SERVICE BULLETIN

M-1163

Safety Recall Code 0116

DYNA GLIDE P&A VOLTAGE REGULATOR COVER

Figure 1. Dyna Glide P&A Voltage Regulator Cover Kit (Part No. 74593-04)

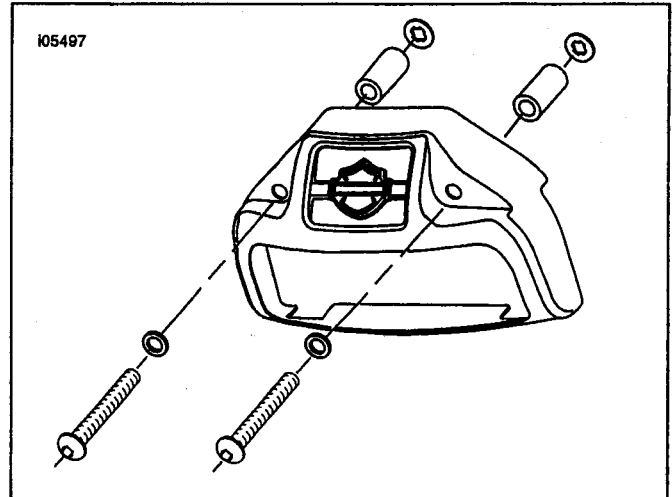
As recently advised in ML-395, Harley-Davidson has learned that normal front suspension travel, under certain riding conditions, could allow the rear tip of the front fender to become locked in the voltage regulator cover installed on certain 2004-05 Dyna Glide motorcycles. By severely limiting front suspension travel and steering, this condition can present an unreasonable risk of accident, injury or death.

1. Remove two button head screws to remove voltage regulator and voltage regulator cover assembly from frame crossmember. Set cover assembly aside for return to Harley-Davidson.

The cover assembly consists of two button head screws, two chrome plated washers, the voltage regulator cover, two zinc spacers, and two nylon retaining washers. See Figure 1.

2. Reinstall voltage regulator using two new screws (Part No. 4740A) obtained from your inventory.
3. Alternately tighten screws to 60-80 in-lbs (6.8-9.0 Nm).
